SOUTHEAST LFA WELLFIELD PROJECT

SETM - Construction Package 1 & 6

ADDENDUM #1

Questions/Responses

FIGURE #
STL-13

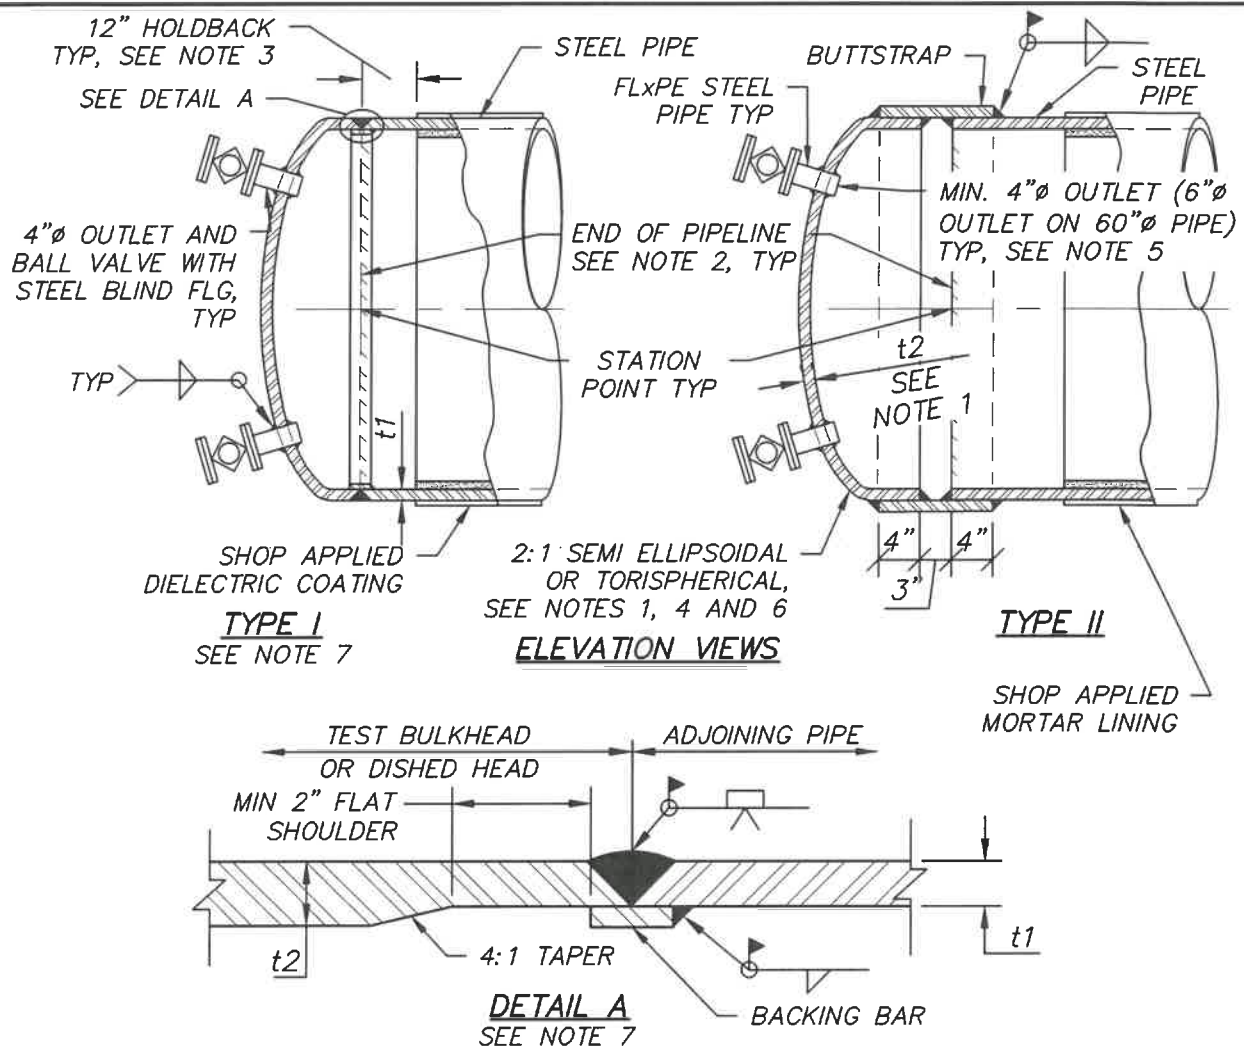
Question 1: On the plans for PRWC, sheet PP-151 calls out a test cap at the end of the line. It references a standard detail (STL-13) in keynote #2 for the test plug, however we can't find this detail in the plans. Please provide.

Response 1: The requested detail is attached to this document.

CHAIN LINK FENCE (TYPICAL)

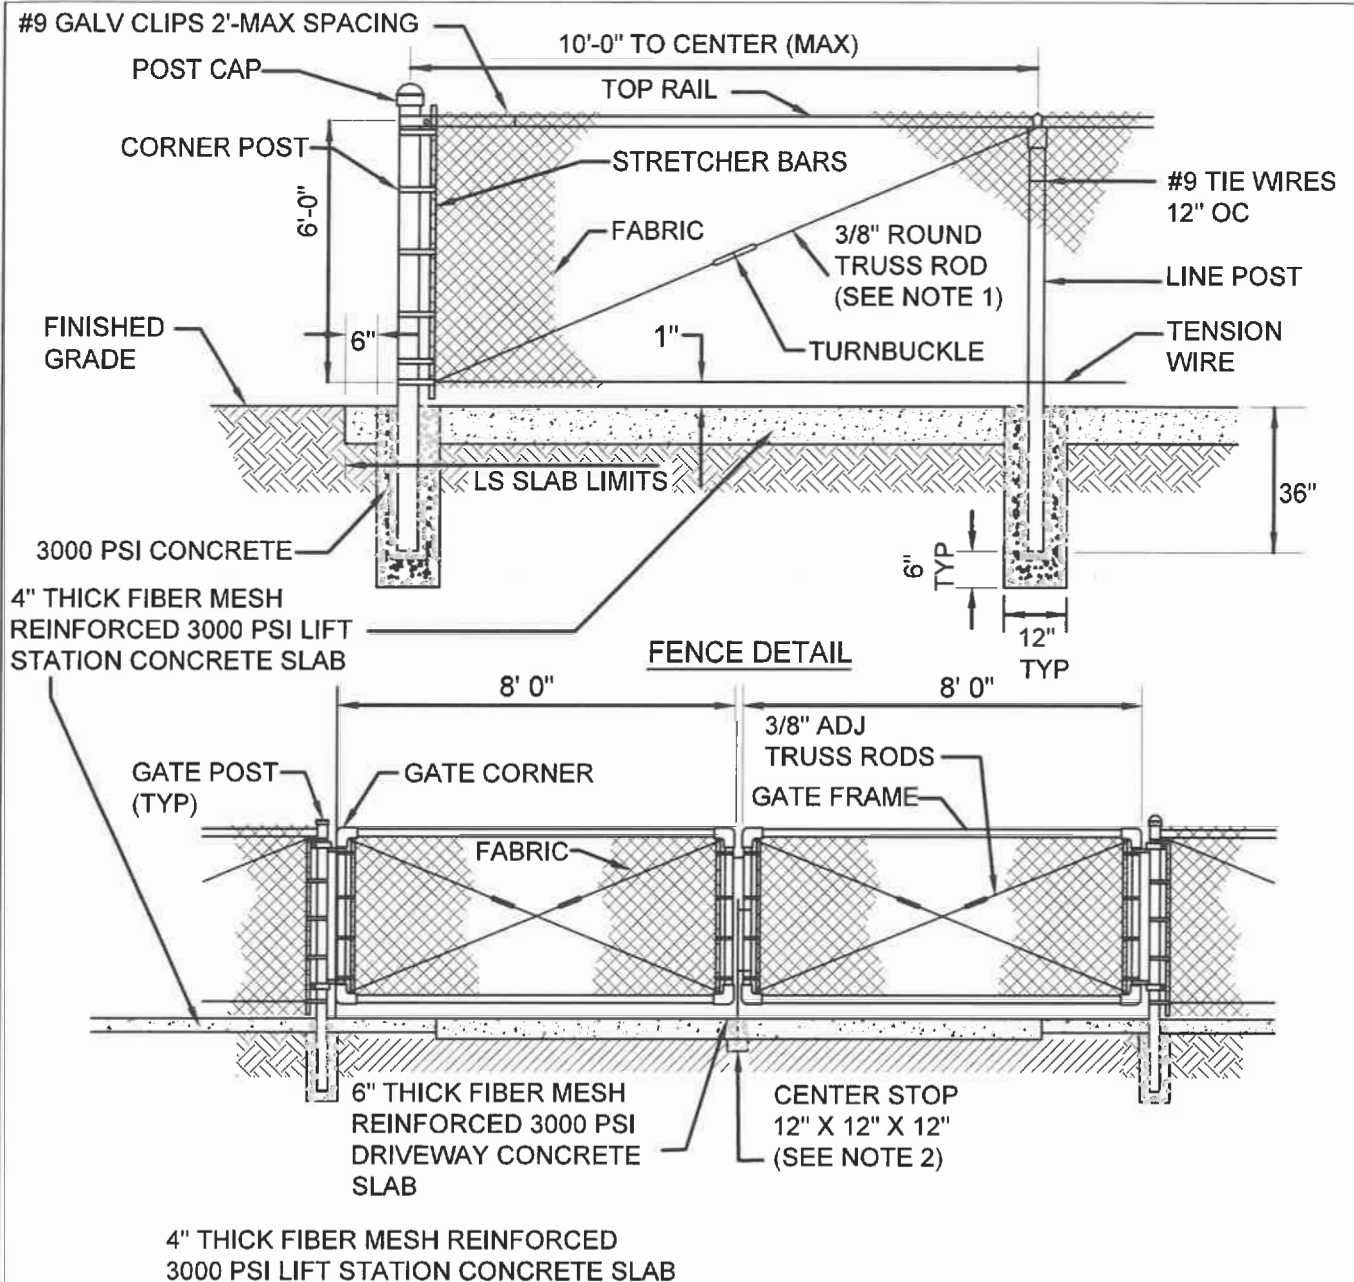
2. Refer to Dwg. C-001. The site plan shows a note, "proposed fence". Please provide a fence detail if this is required.

Response: The following typical fence and gate detail is to be used for the site. See attached detail.
